Service Bulletin

Subject: RATTLE NOISE FROM BOTTOM OF A-PILLAR	Bulletin No: 09-001/14
	Last Issued: 03/28/2014

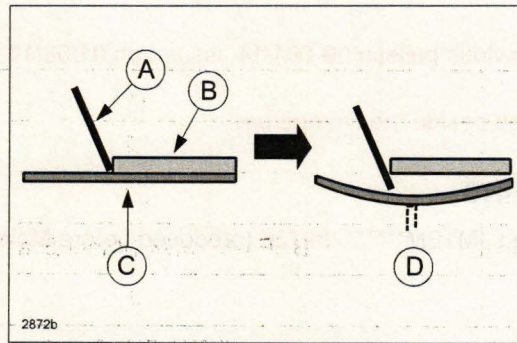
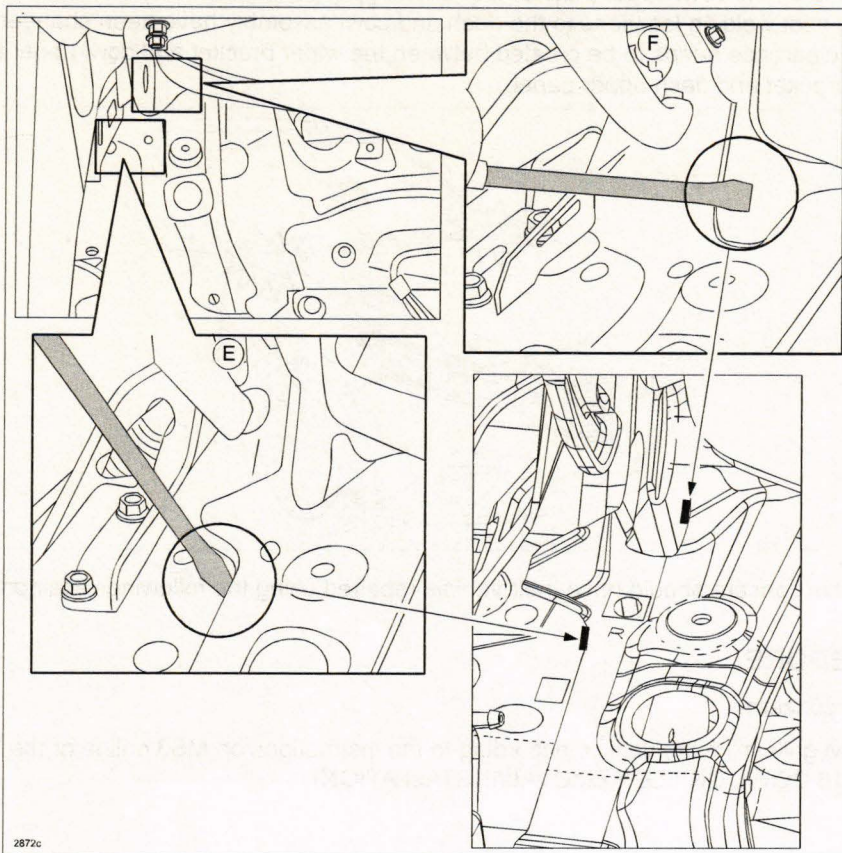
Some vehicles may exhibit a rattle noise from the bottom of the A-pillar when driving on rough roads or over bumps. This is caused by the cowl upper plate and/or dash upper panel interfering with the wiper bracket. To correct the problem, spot welding locations to the dash and cowl assembly have been changed. For the affected vehicles, a clearance needs to be created between the wiper bracket and cowl upper plate and between the wiper bracket and dash upper panel.

3. Place the tip of a covered* flat-blade screwdriver (A) between the two panels (B and C) at the joint (between the wiper bracket and cowl upper plate (E) and between the wiper bracket and dash upper panel (F)) and hit the head of the screwdriver with a hammer to create a clearance of approximately 0.5 mm (D) between the two panels.

***NOTE:** To avoid damage to the paint, wrap protective tape around the tip of the screwdriver. If the panels are scratched, apply appropriate corrosion protection primer.
